Dean Moor Solar Farm

Environmental Statement: Appendix 7.8 – Arboricultural Impact Assessment

26 August 2025
Prepared by: Stantec UK Ltd
PINS Ref: EN010155
Document Ref: D2.17
Deadline: 2
Revision: 2

Table 1.1: Revisions to Appendices B and C of the AIA

Appendix B Tree Constraints Plan

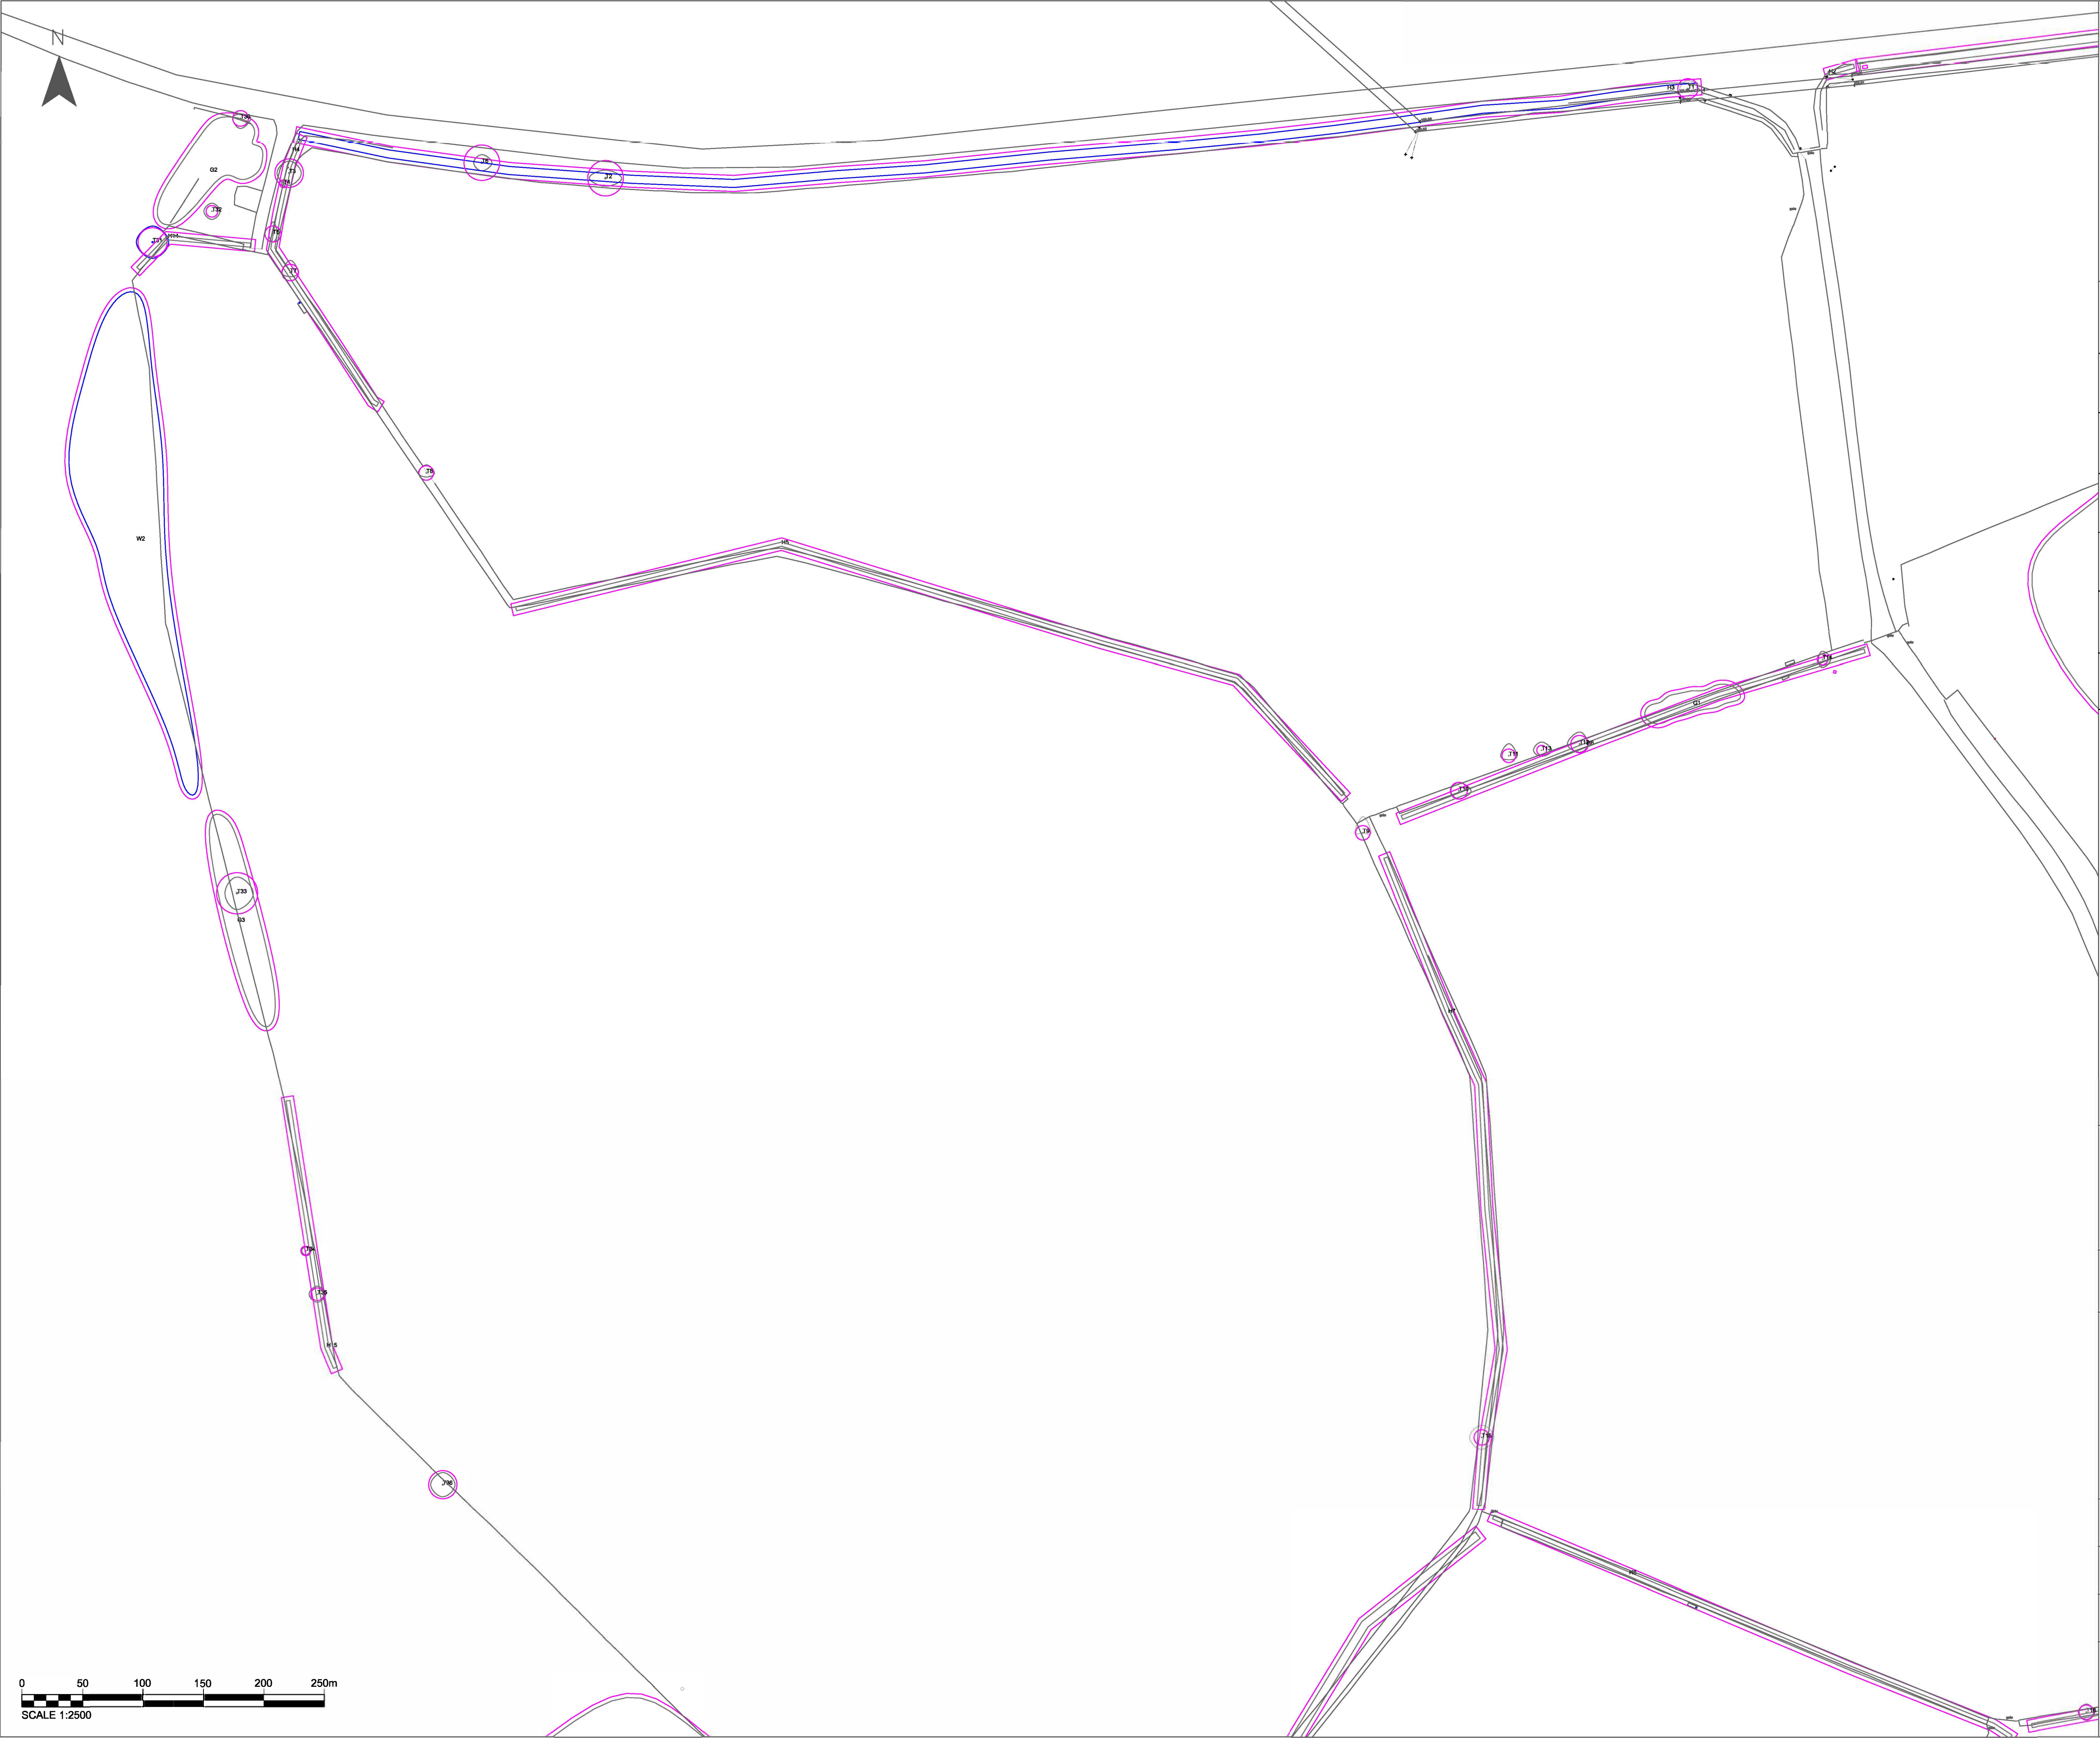
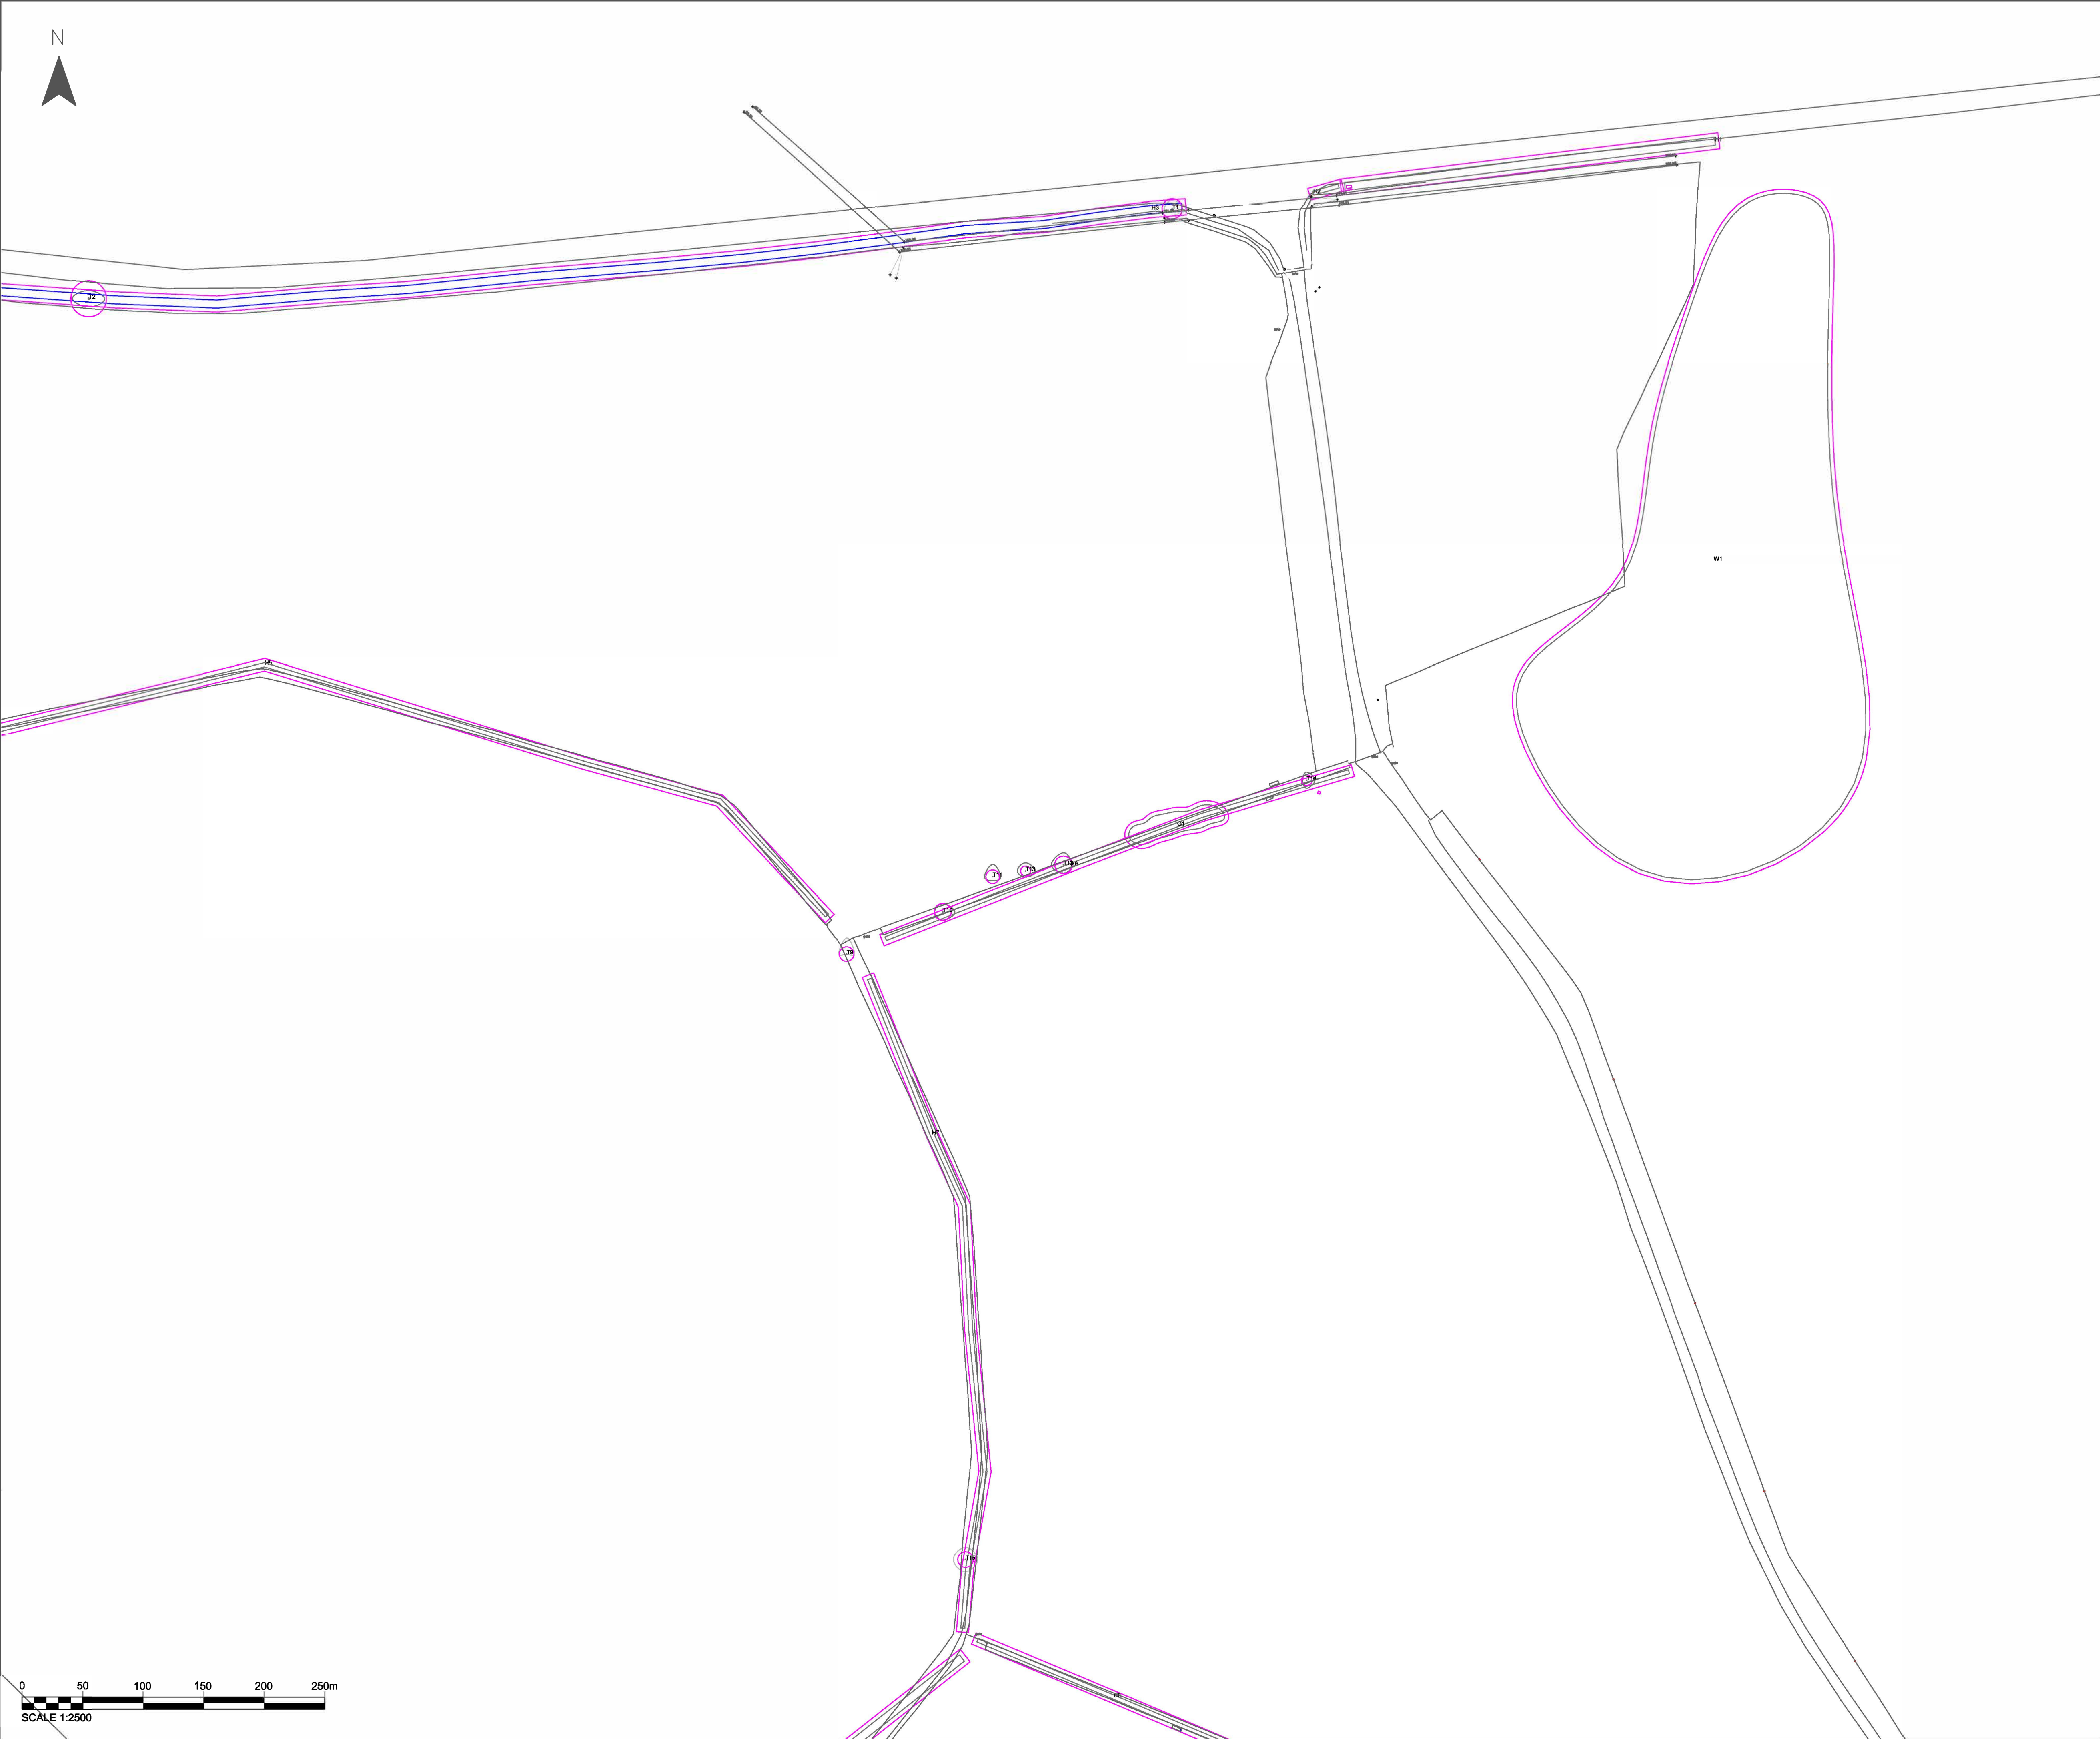
Revision	Reason
Change of the plan title in the TCP from 'Location Plan' to 'Tree Constraints Plan'	To make it clear that the plan is displaying the TCP. As the Location Plan is a different figure within the ES.
A renumbering of the sheets included in the TCP. Changing the order from 0-22 to 1-23.	To enable the first sheet within the TCP is numbered 1 rather than 0.
Change of the plan title in the TPP from 'Location Plan' to 'Tree Protection Plan'	To make it clear that the plan is displaying the TPP. As the Location Plan is a different figure within the ES.
A renumbering of the sheets included in the TPP. Changing the order from 0-22 to 1-23.	To enable the first sheet within the TPP is numbered 1 rather than 0.
